ZONING REVIEW
MEMO

REQUEST LETTER OF INTERPRETATION

Re: 265 Adams Ave.
River Edge, NJ 07661
Block:506 / Lot:3 / Zone:R-1

Re: Proposed Covered Deck (277sq.ft.)

SITE PLAN
1 IN = 10 FT

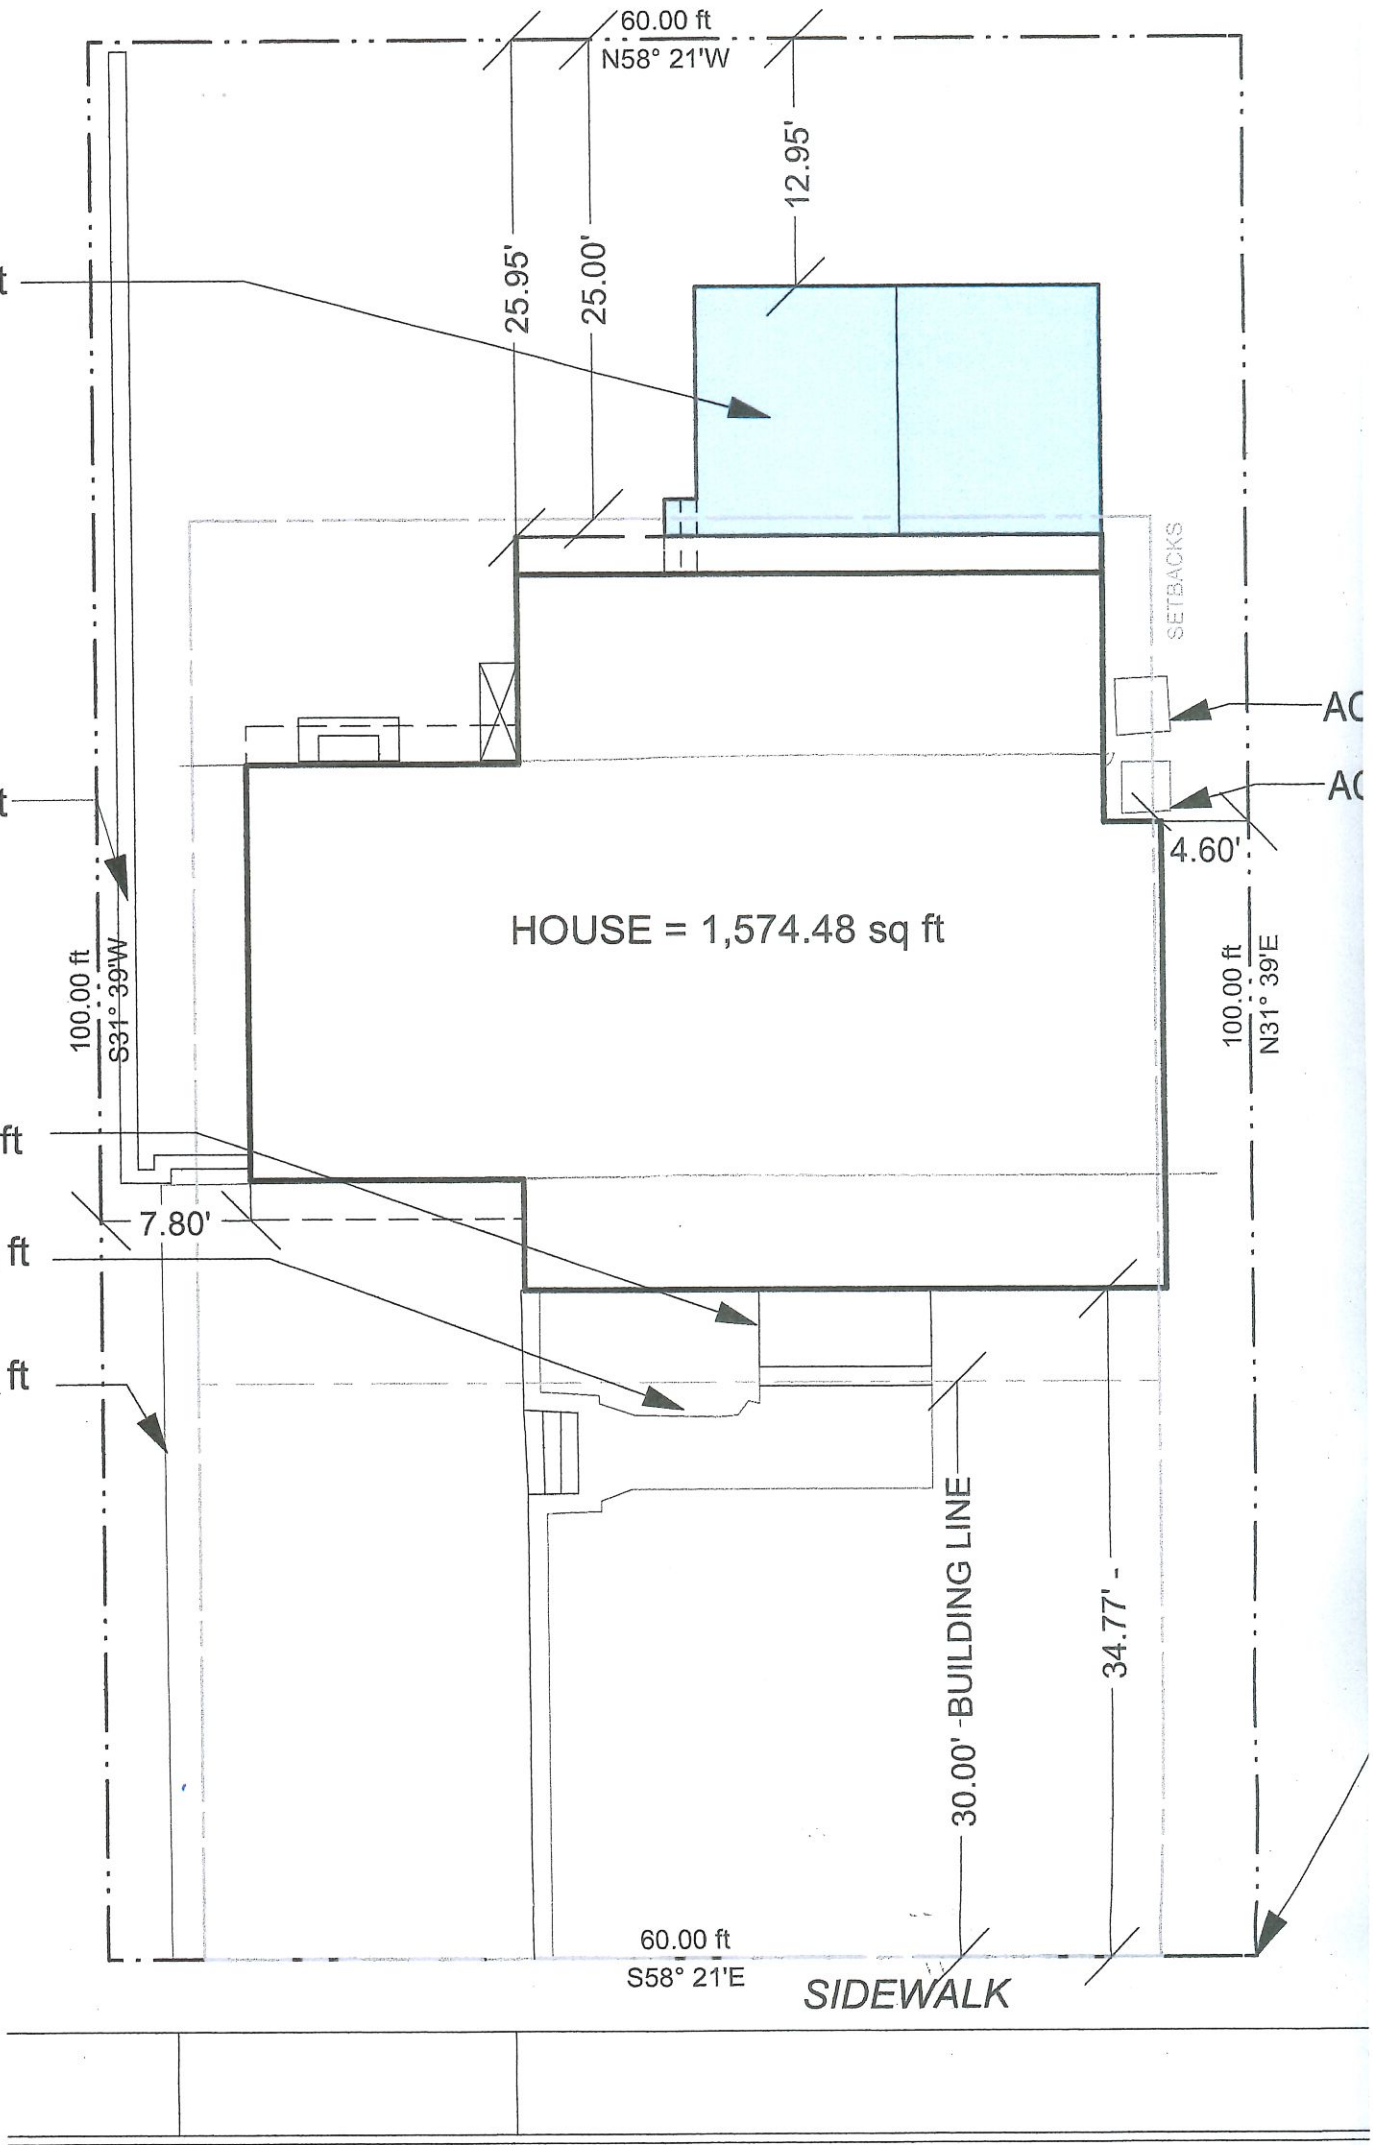
1. §416-14 Maximum Building Coverage and §416b Schedule of Zoning District Area, Bulk and Yard Requirements. The R-1 Zone permits a maximum Building Coverage of 25%.
 - The proposed Building Coverage would be 1,887sq.ft.(31.5%), which is over the maximum Building Coverage of 1,500sq.ft. by 387sq.ft. (6.5%). A variance would need to be obtained.
2. §416-15 Maximum Lot Coverage and §416b Schedule of Zoning District Area, Bulk and Yard Requirements. The R-1 Zone permits a maximum Lot Coverage of 35%, where 5% of the 35% is reserved for Yard Amenities (decks, patios etc.).
 - The proposed Lot Coverage would be 2,867sq.ft. (47.8%), which is over the Maximum Lot Coverage by 767sq.ft. (12.8%). A variance would need to be obtained.
3. The proposed Rear Yard Setback of 12.95ft. would encroach into the minimum setback of 25ft. by 12.05ft.. A variance would need to be obtained.
